ADDENDUM No. 1

DATE: November 22, 2024

PROJECT: Village of Algonquin
Braewood Pump Station Rehabilitation

TAI PROJECT NUMBER: ALG-037

Braewood Pump Station Rehabilitation
Details
Algonquin, Kane County, Illinois

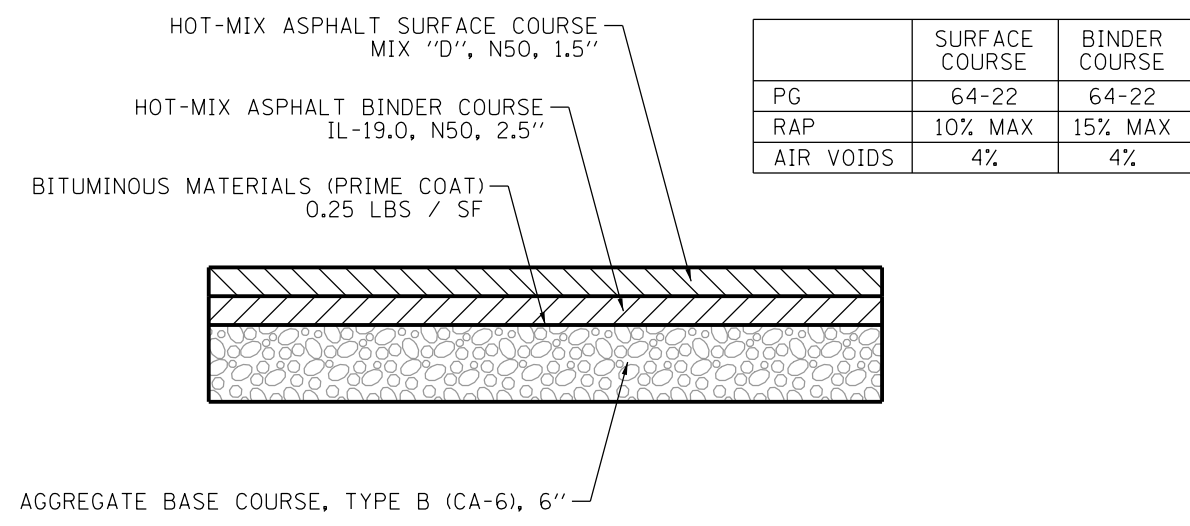
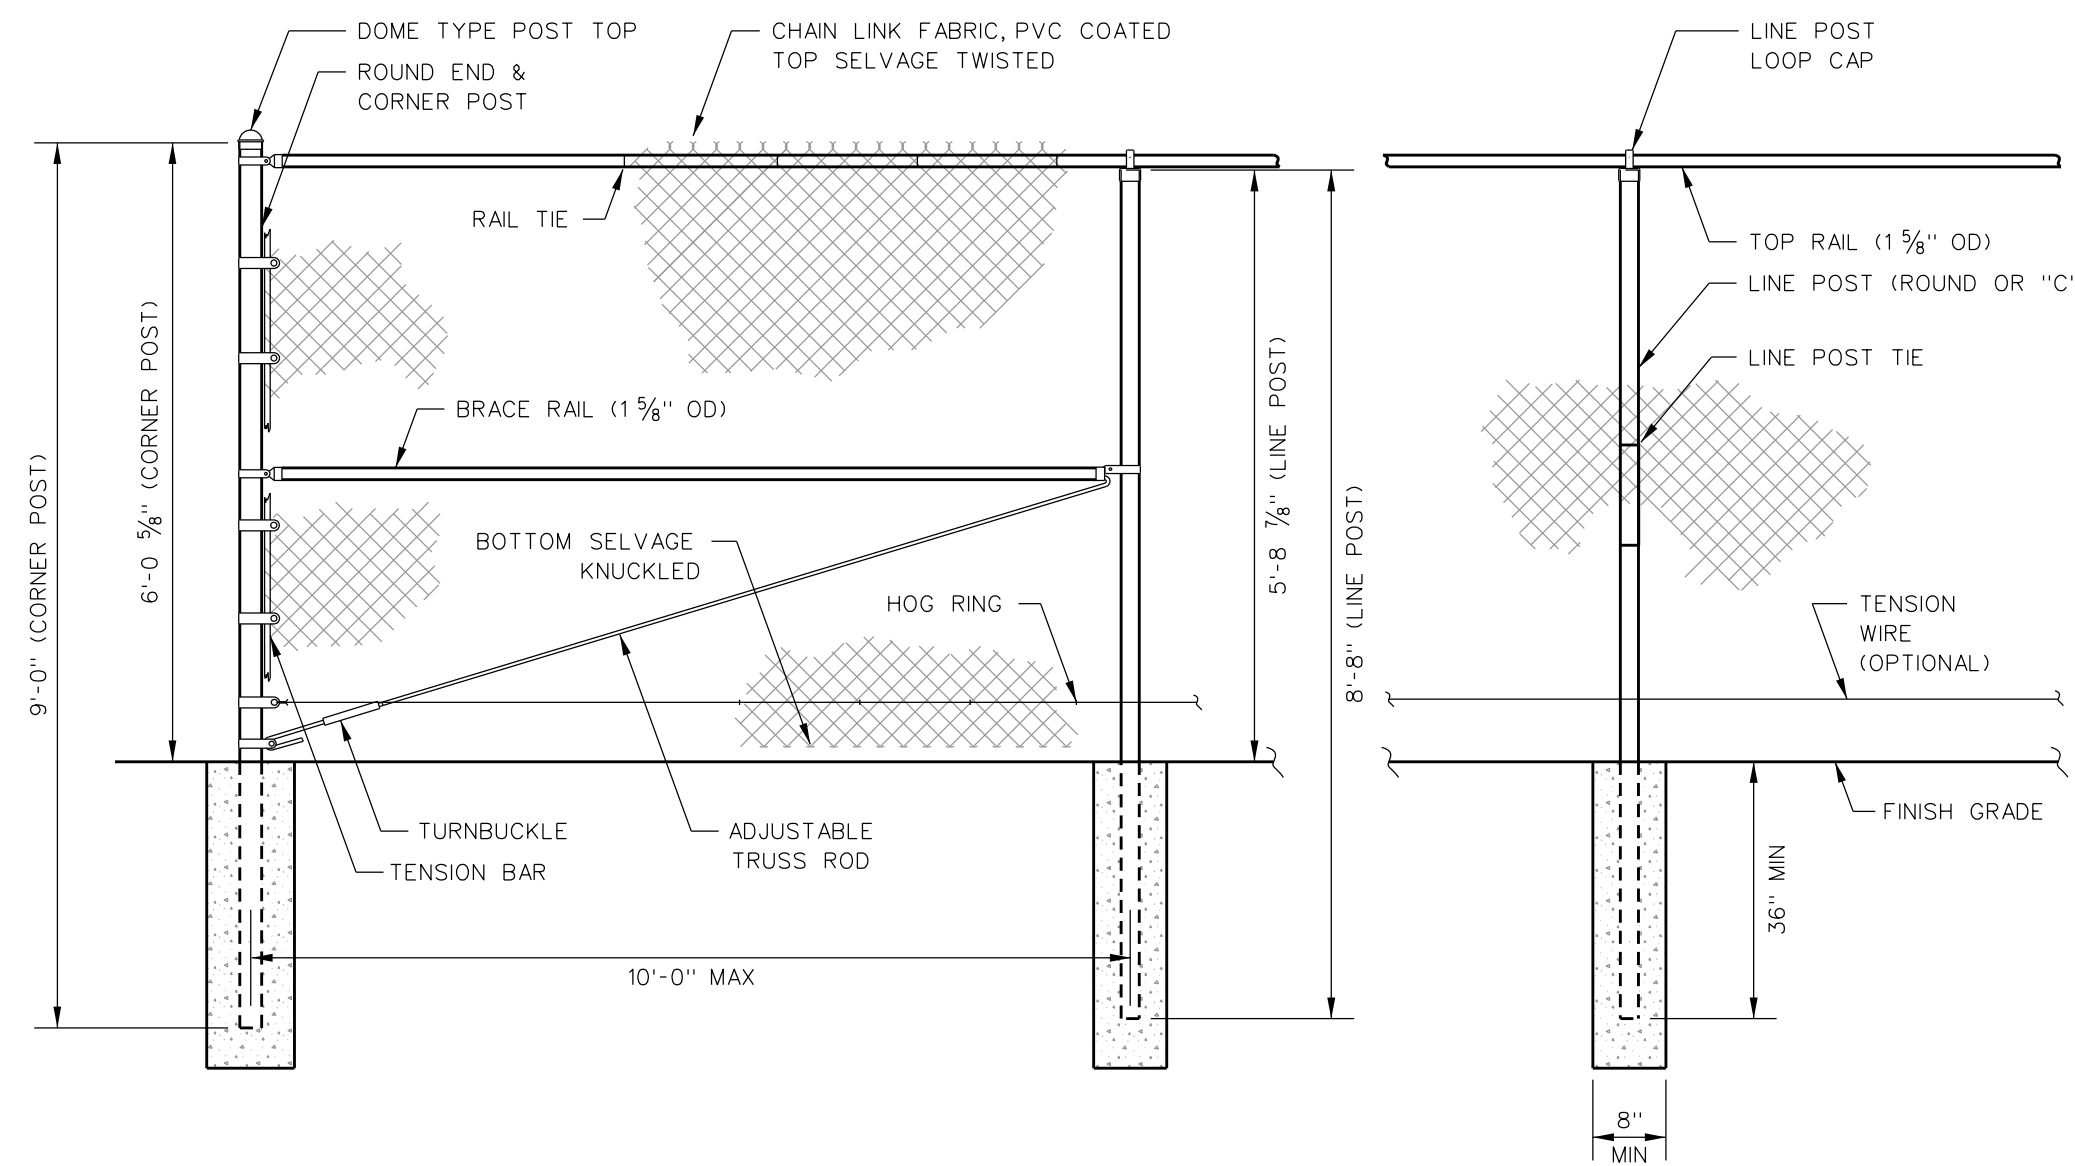
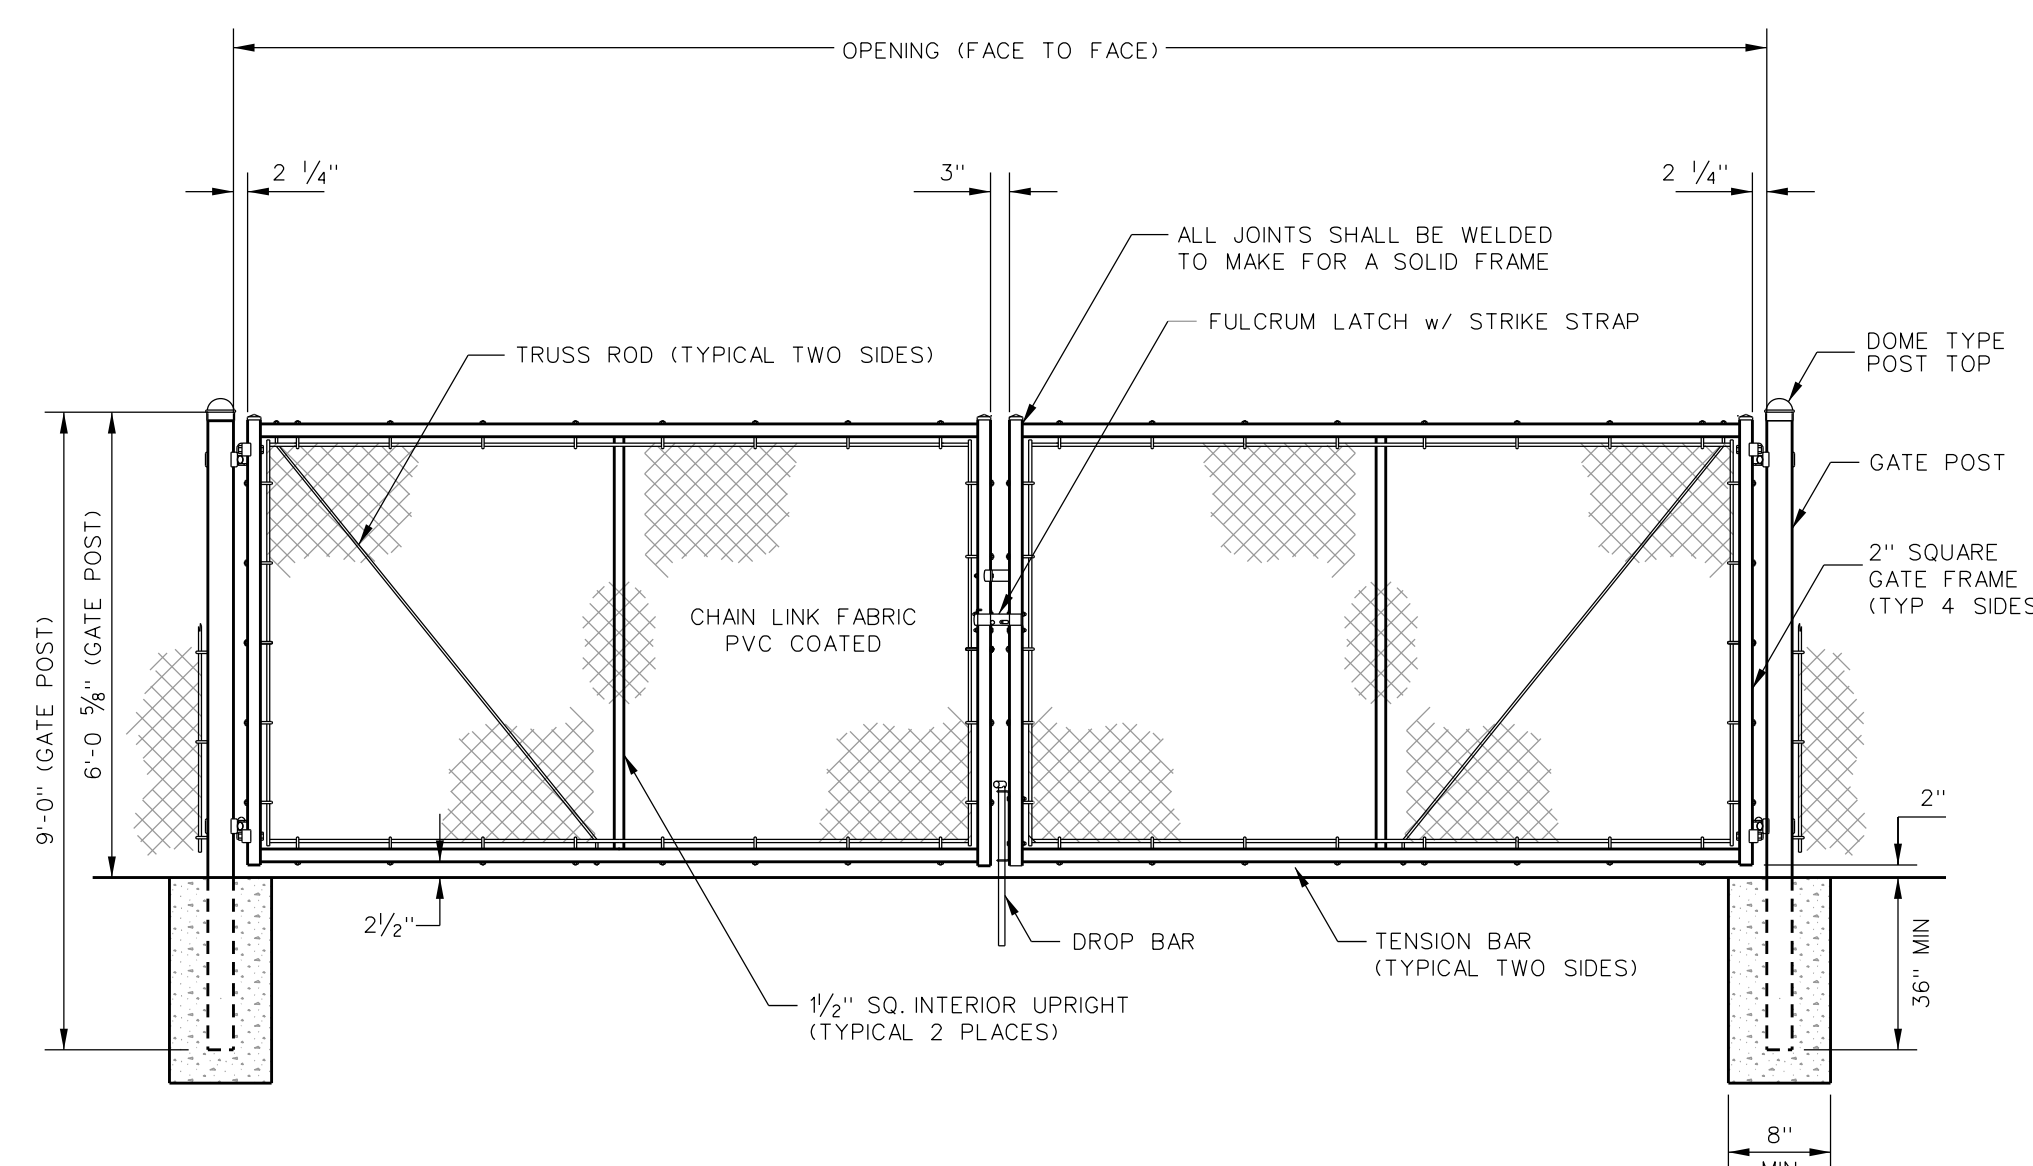
6. Sheet C.2 – Details

- A. Detail “Typical Hot Mix Asphalt Pavement” deleted.

1. Drawing C.2 provides details for the “Typical Hot-Mix Asphalt Pavement” and “HMA Driveway with 6” Aggregate Base.” Which detail should be used for repairing the area where the existing valve vault is to be removed?

3. Drawing C.1 indicates a fence and double gate are to be installed over an existing concrete slab. Could you confirm if the existing concrete slab should be removed to construct the foundation for the gate and fence as detailed in Drawing C.2?

Response: Please use “HMA Driveway with 6” Aggregate Base” detail. Revisions to sheet C.2 (enclosed) include deletion of the second pavement detail.

Response: The existing concrete slab is to remain. As-built drawings indicate that the original 8” slab, reinforced with #5’s at 12” oc in the bottom of the slab, was cored for post installation and the posts grouted in place. Contractor shall attempt to twist out the existing posts adjacent to the existing gate using a pipe wrench. If unsuccessful, cut off the existing posts as close as possible to the slab without damaging adjacent structure. Core out or grind down the existing fence posts from the slab but do not go deeper than 5” into the slab. Patch the holes using non-shrink grout. New fence posts should be installed by coring holes slightly larger than the posts, not to exceed a depth of 5”, and using epoxy adhesive to secure the posts into the slab. Posts diameter as recommended by gate manufacturer.

Photo 1

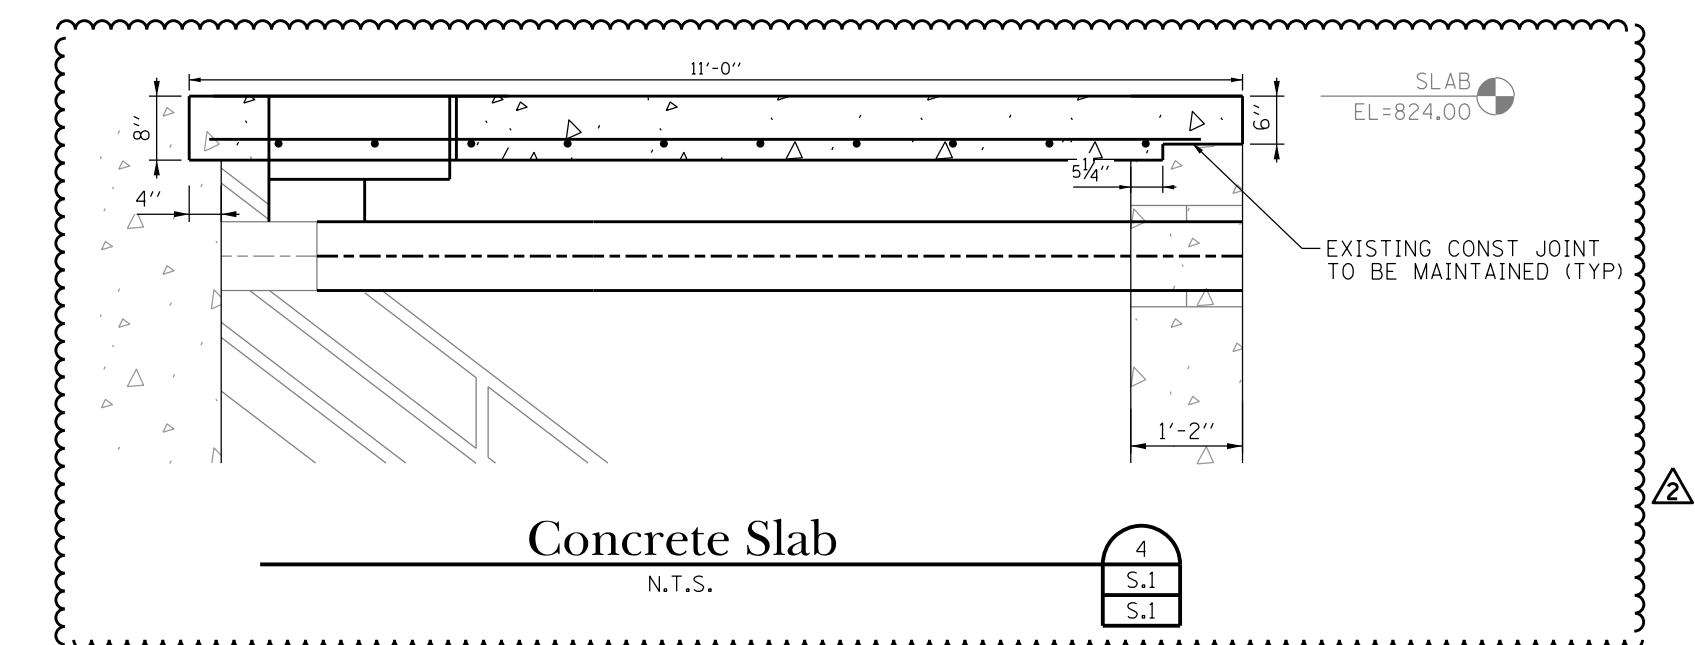
7. Sheet S.1 – Upper Level Structural Plan and Details

- A. Sections 2, 3 and 4 added.
- B. Photo 1 added.
- C. Pad detail replaced.

Control Room HVAC Plan
SCALE: 3/8" = 1'-0"

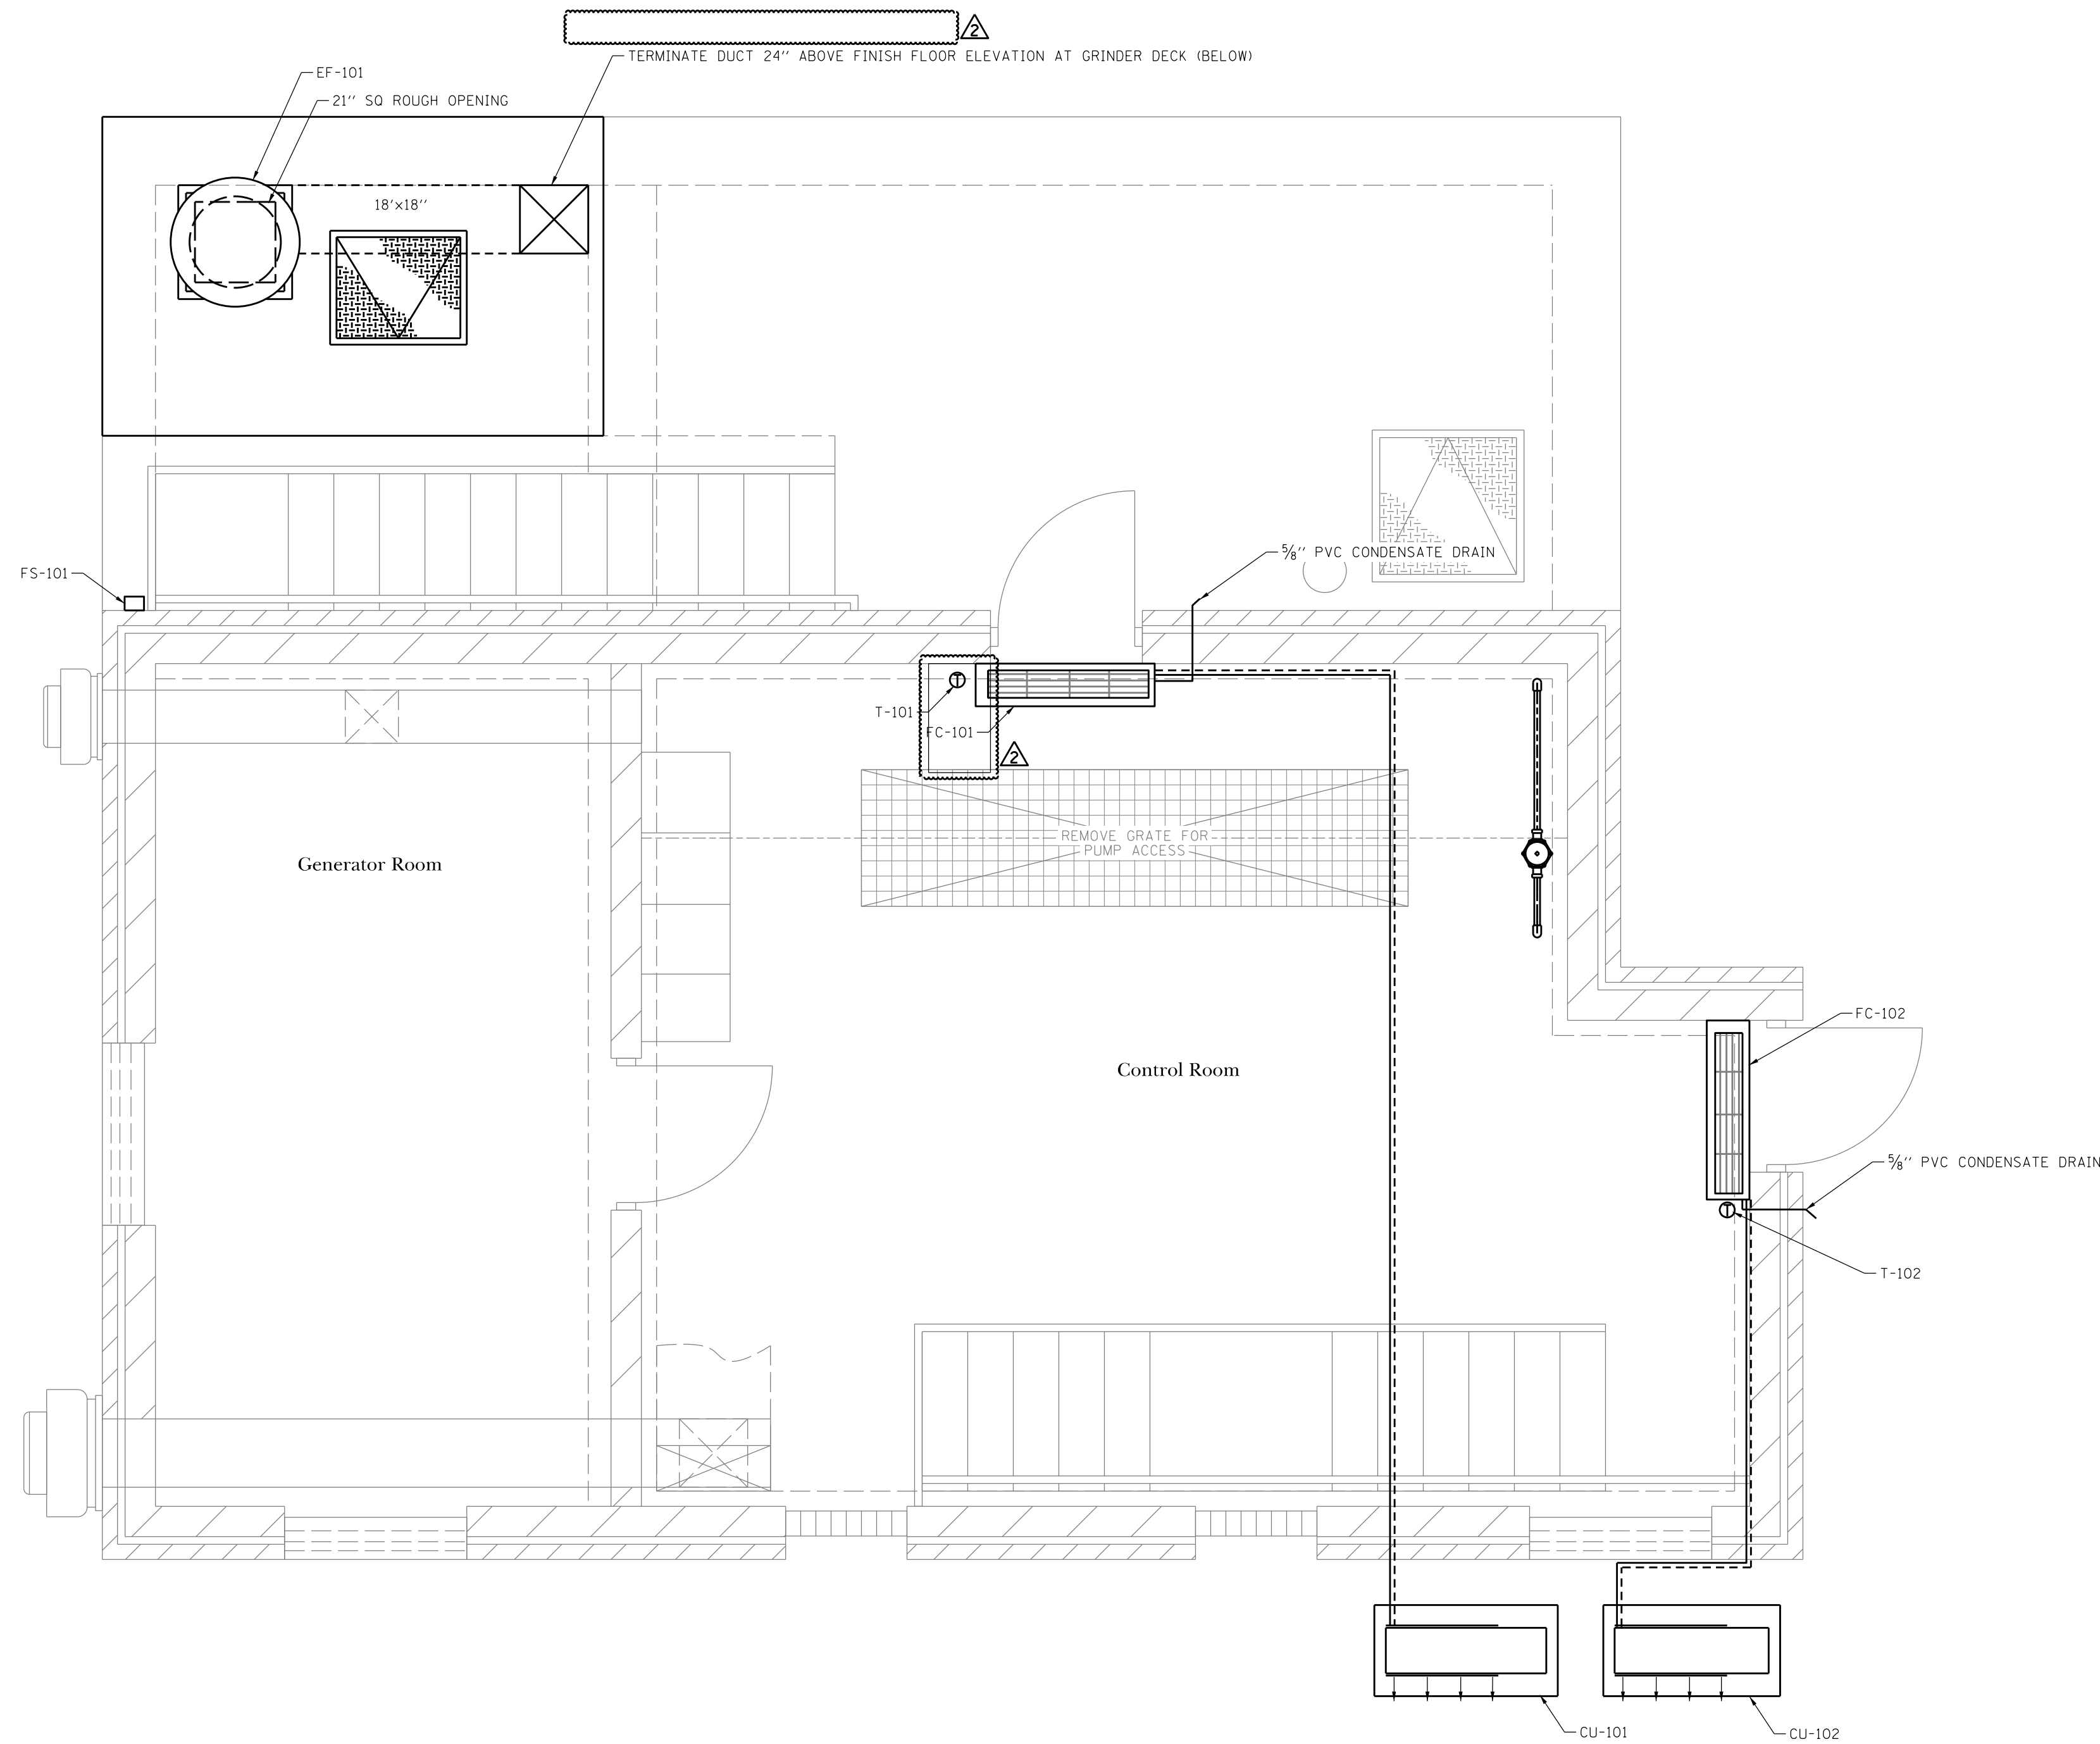
8. Sheet M.1 – Control Room HVAC Plan

- A. Location of proposed fans switch moved.
